Office Action Summary

10/533,990

WUNDERLICH, ANDREAS

DETAILED ACTION

EP 0 501 860 A1

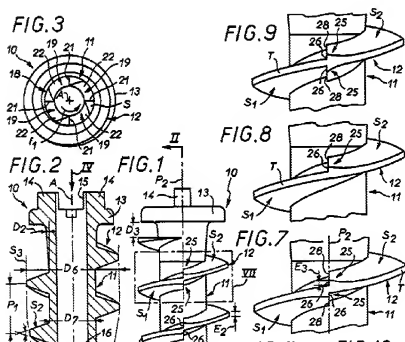
[6] As best understood, claims 1-9 and 13-14 are rejected under 35 U.S.C. 102(b) as being anticipated by Auger, EP 0501860.

Examiner is very unsure of what is being claimed, but as best understood, Auger teaches in the Figures and abstract a screw capable for use on hard materials, with a shaft, head at one end, tip, and a thread with cutting teeth having equal but opposite sides that are laterally offset to opposite sides of the thread's longitudinal centerline. (see new matter above). There are a series of cutting teeth formed along at least one half turn of the thread—the series is formed by considering multiple half turns to include multiple teeth. As best understood, noting that paragraph [0008] is the only disclosure of a sawtooth, examiner considers Auger Fig 1 to be a sawtooth profile, with teeth disposed to opposite sides of the longitudinal centerline (see new matter above).

The thread has a flattened crest forming a narrow face (T) with edges 28 extending across it, and there are a plurality of narrow faces along at least one half turn – the plurality is along several turns, which are at least one half turn, and there are cutting edges. The transverse leading edges on at least one side are roughly radially disposed and extend all the way down to the shaft (Fig 10, and Fig 6, not copied, best shows this). The thread has the alternating offset of the cutting teeth providing alternating protrusions and notches along sides of the threads (Figures, esp. 8,5,10) The teeth are along a longitudinal centerline of the thread and have leading edges as

described, and the figures show cutting teeth edges disposed along radii all the way down to the screw shaft. (Figures). The included angle between sides S1 and S2 of the thread are in a range of 20-30 degrees at the portion due to penetrate the drilled hole wall. The included angle between sides S1 and S2 of the thread are in a range of 45 to 60 degrees over the transition zone immediately adjoining the shaft. Fig 7 and 8 show the teeth (on upper vs lower sides) offset from one another by the width of their face. The set of teeth vary over the shaft length- some are on one side, some are on the other, some have "double" teeth (fig 9 and 7), which is varied.
